ADDENDUM 01

This addendum is considered to form part of the contract document issued for this Request for Quotation. Its content precedes previously issued documents in case of conflicting information.

E-000

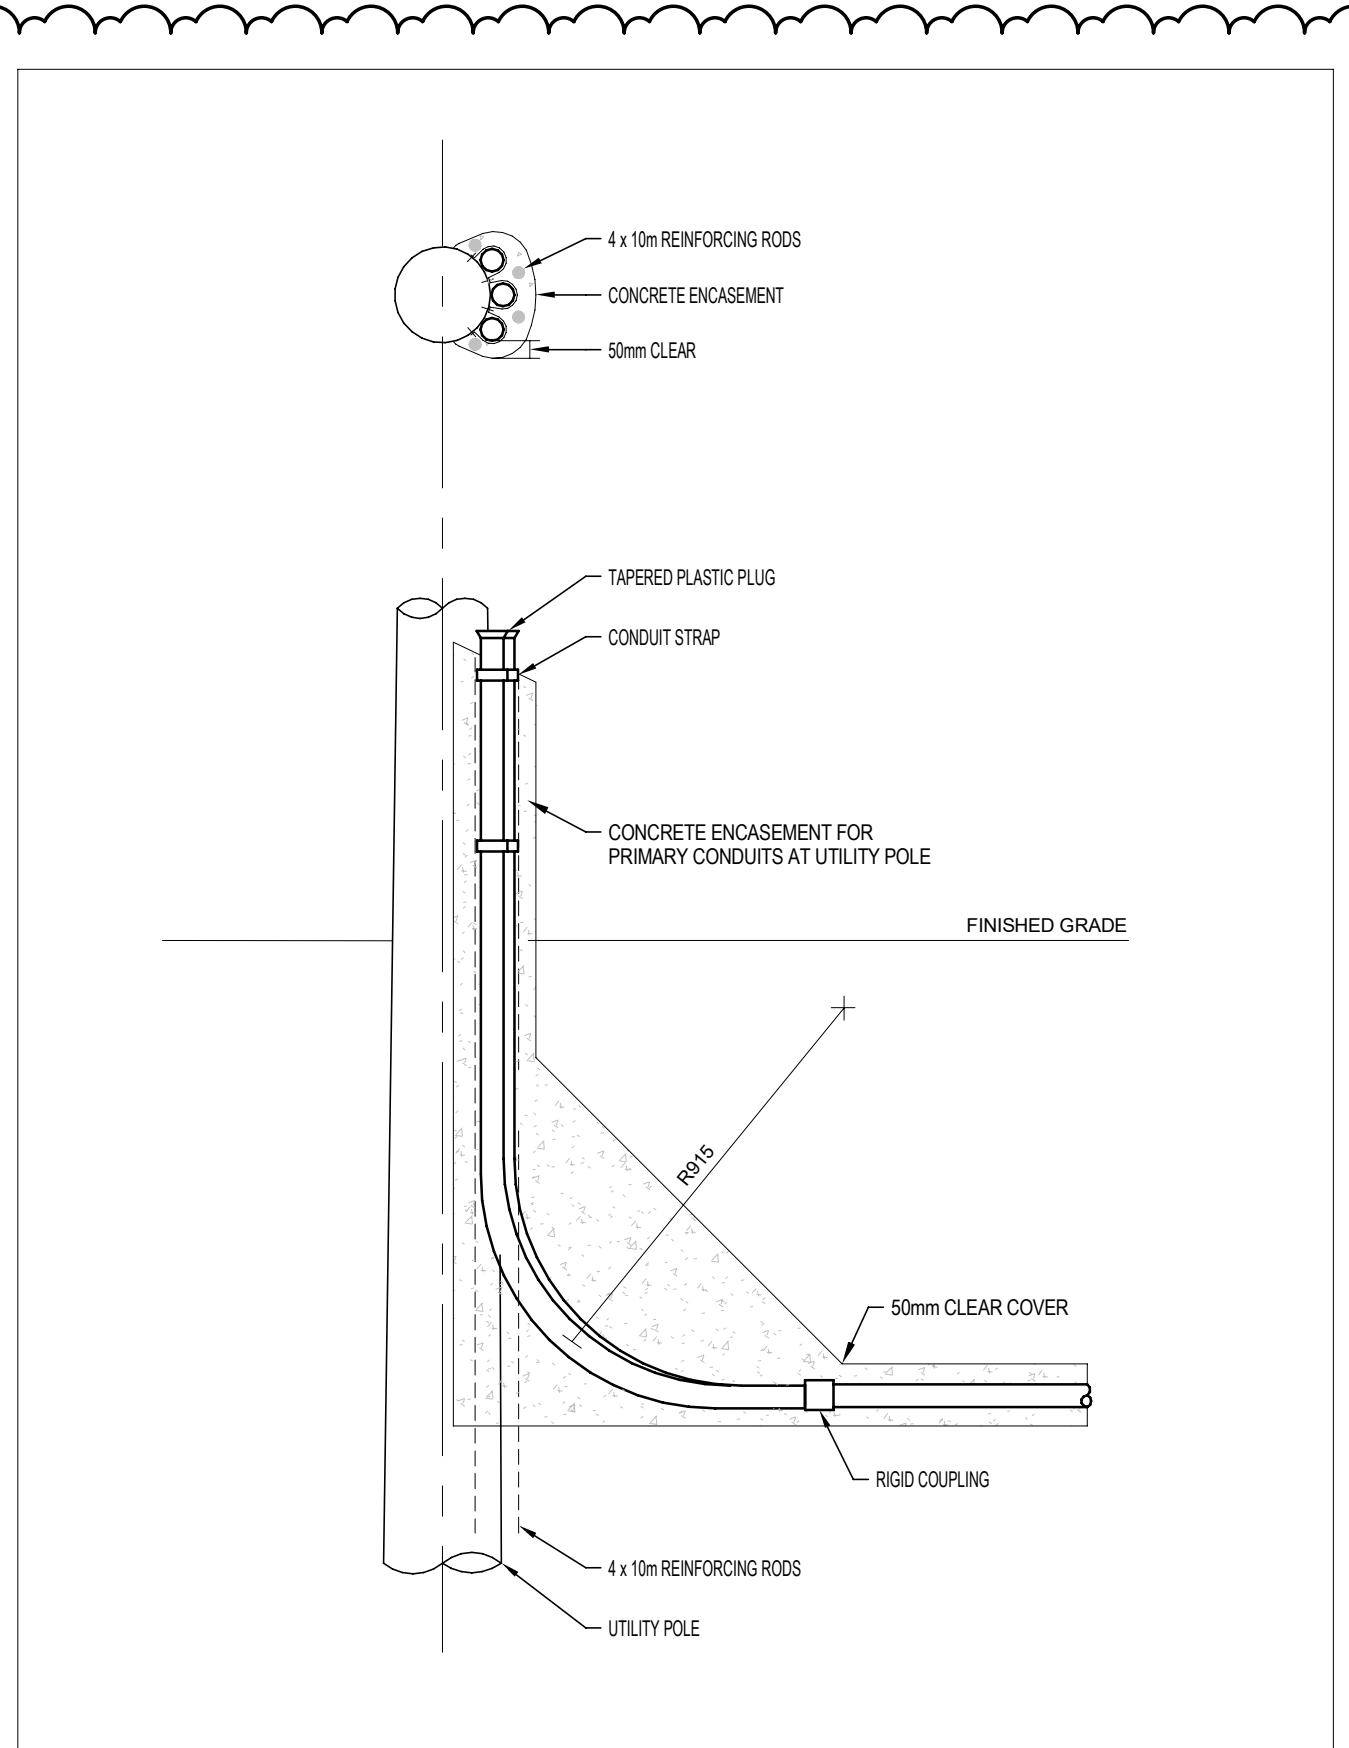
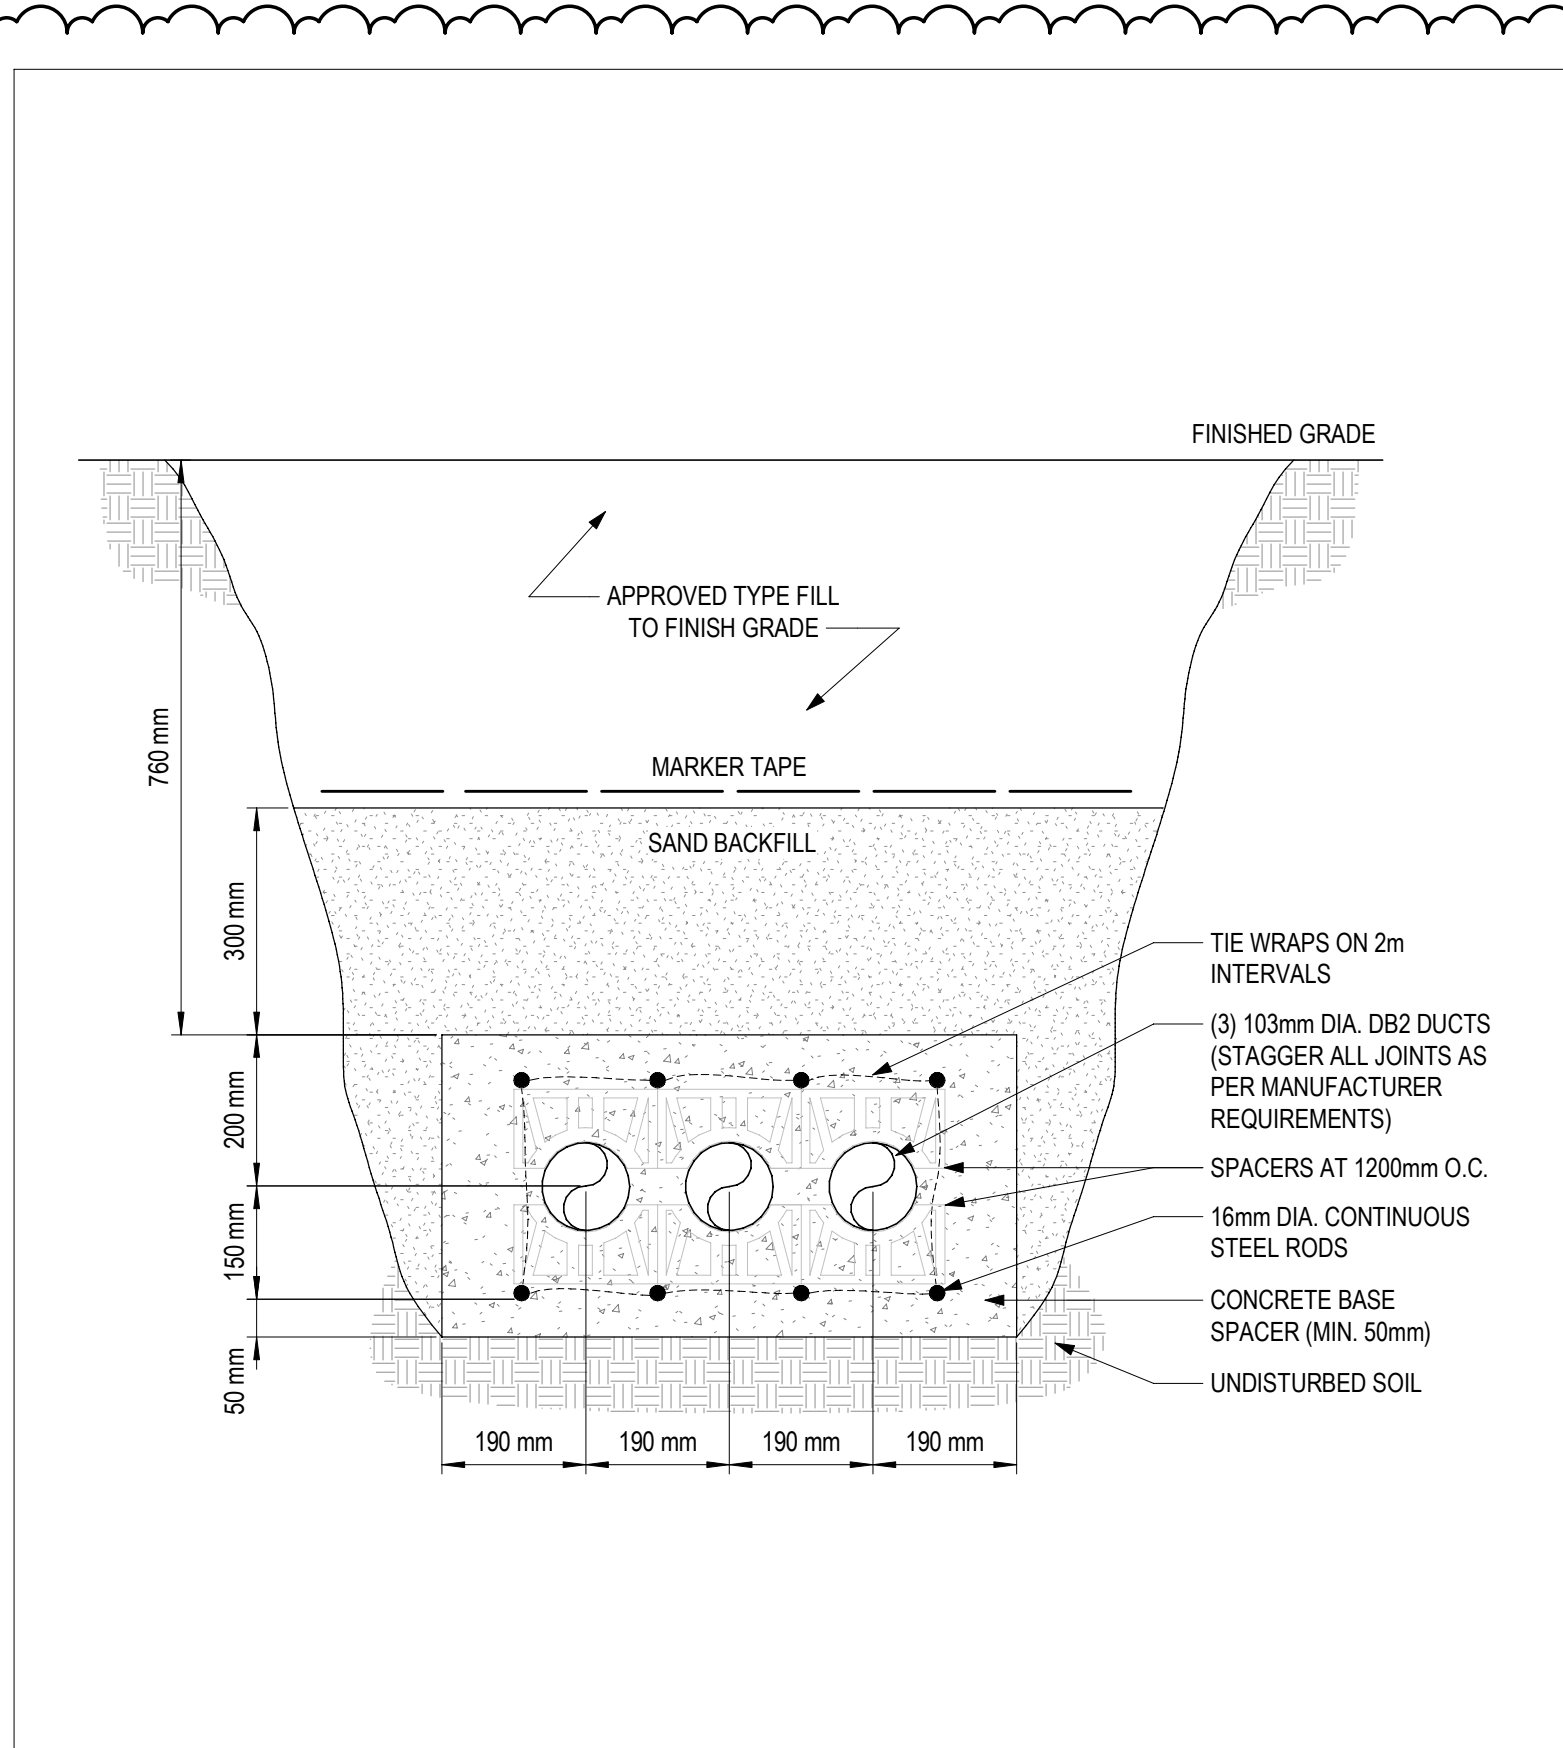
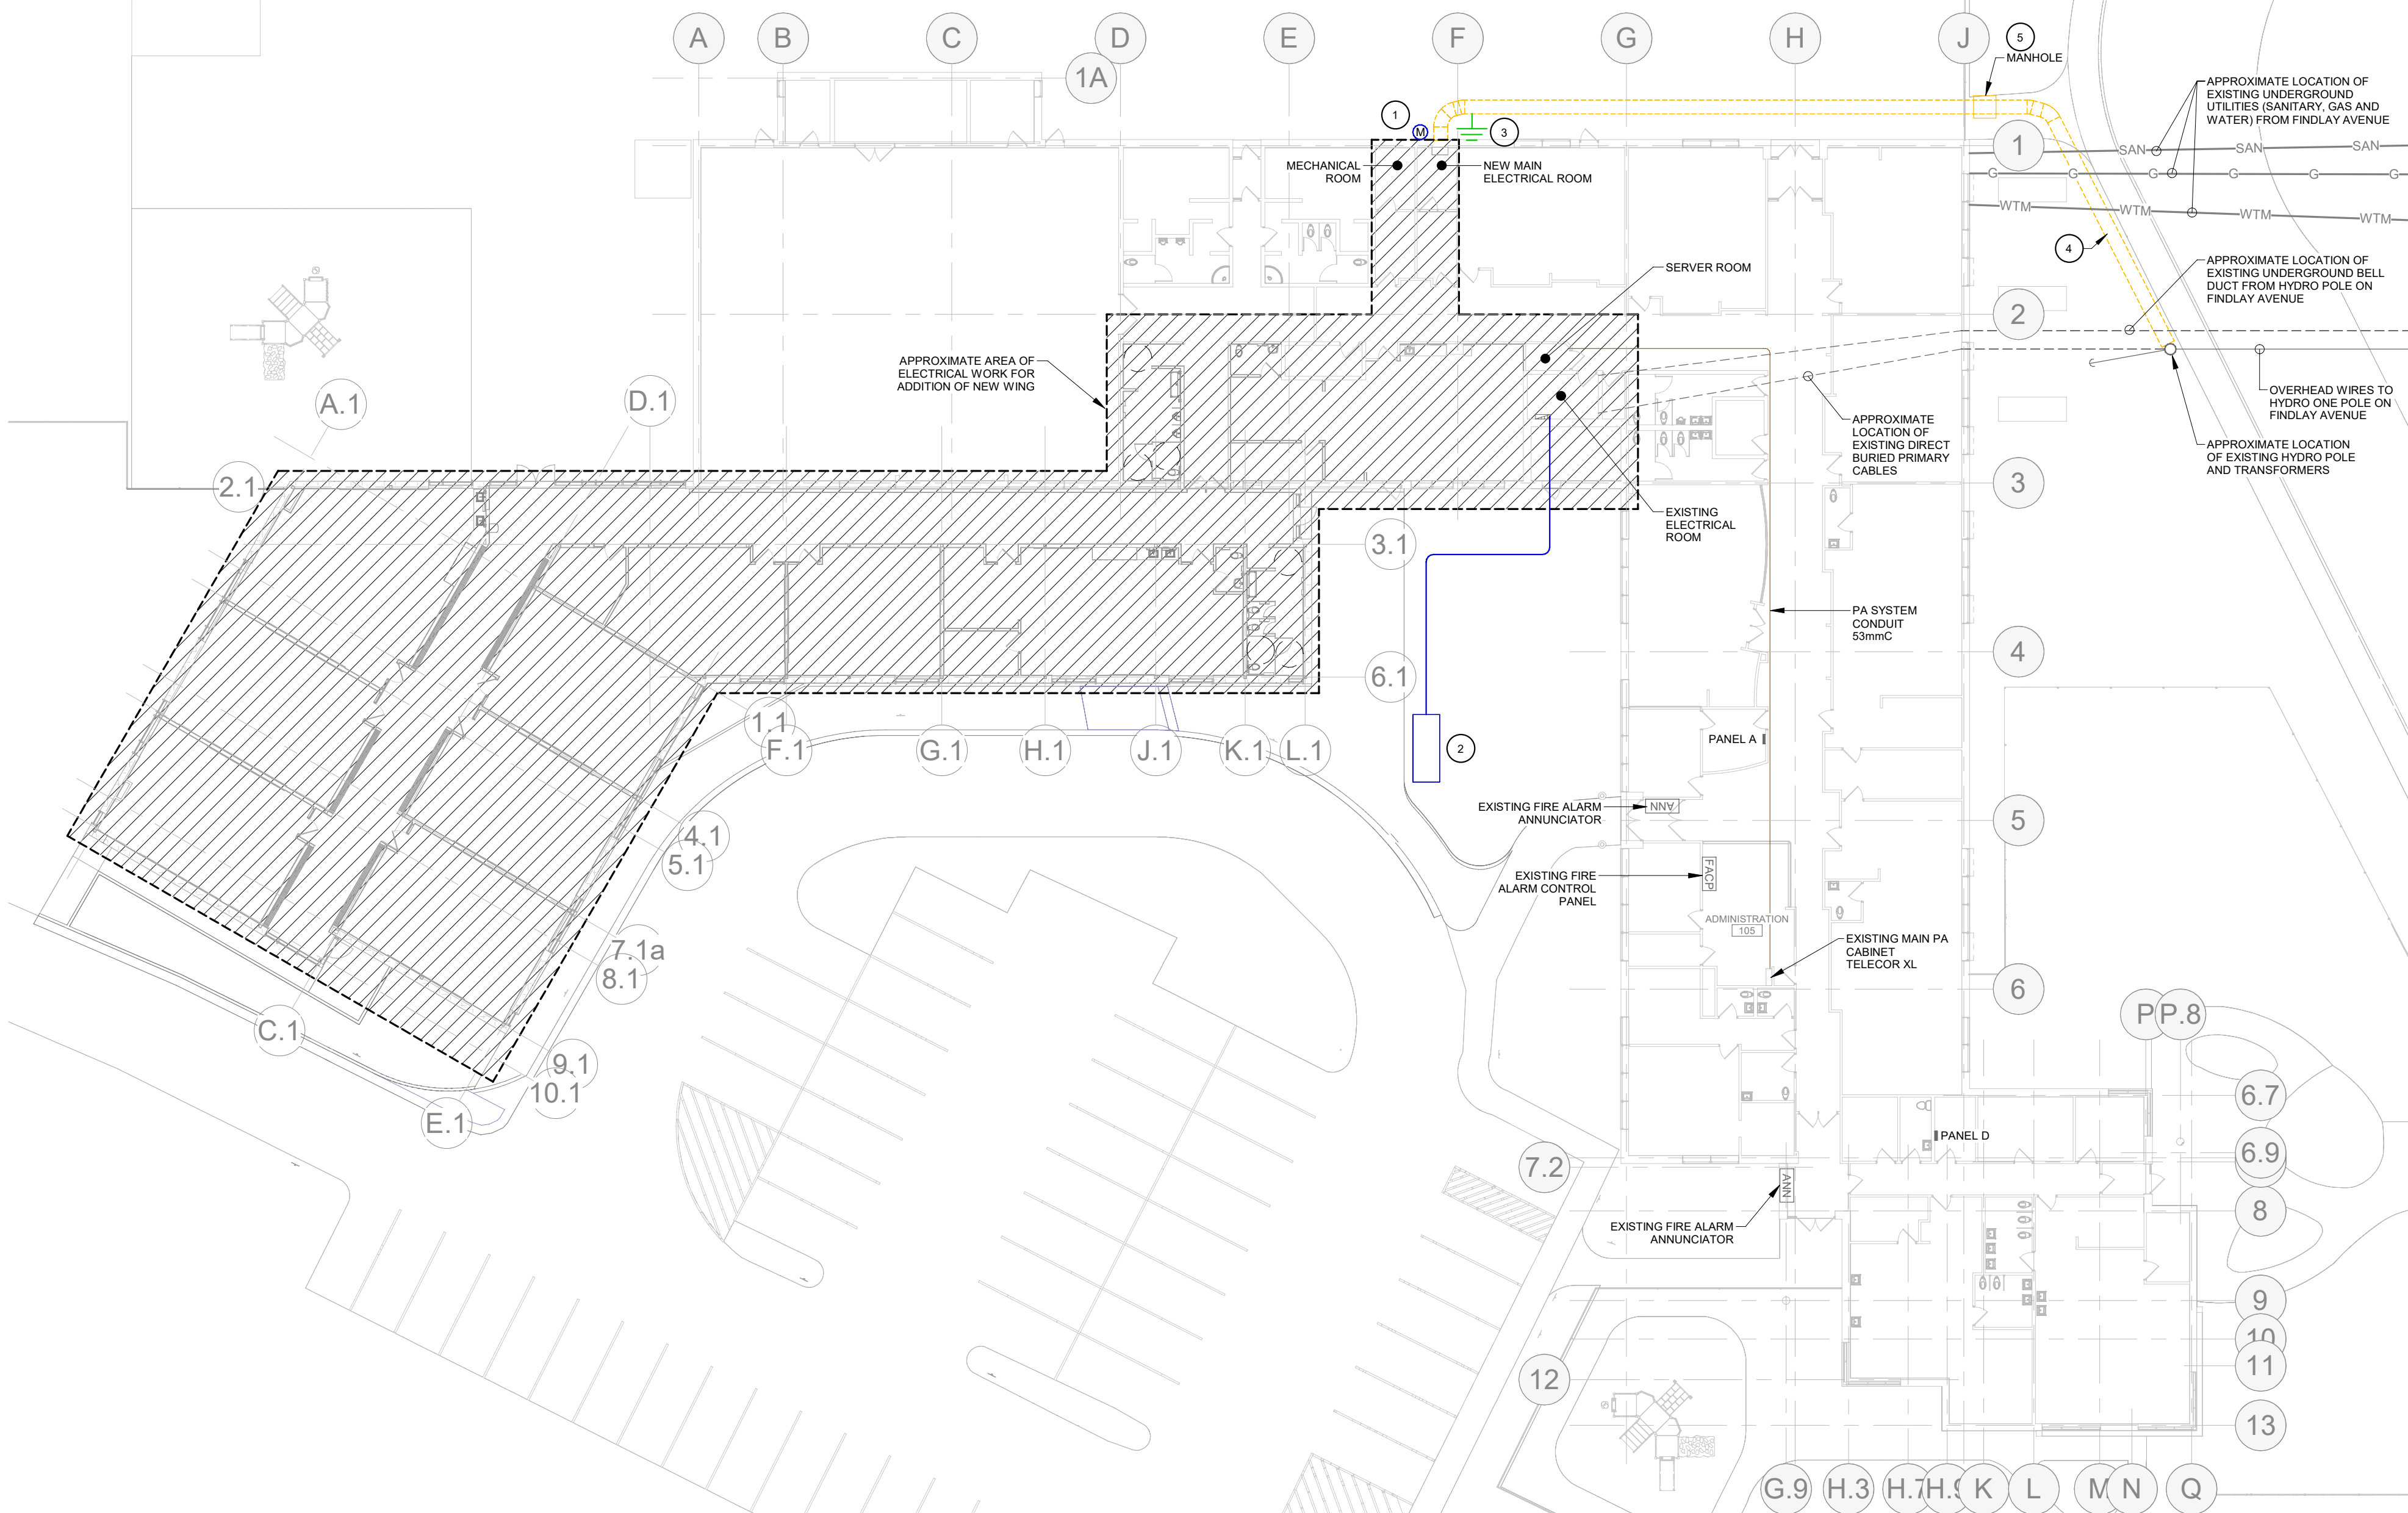
2.1 Drawing E-000

- Refer to drawing for revised details 2 & 3.
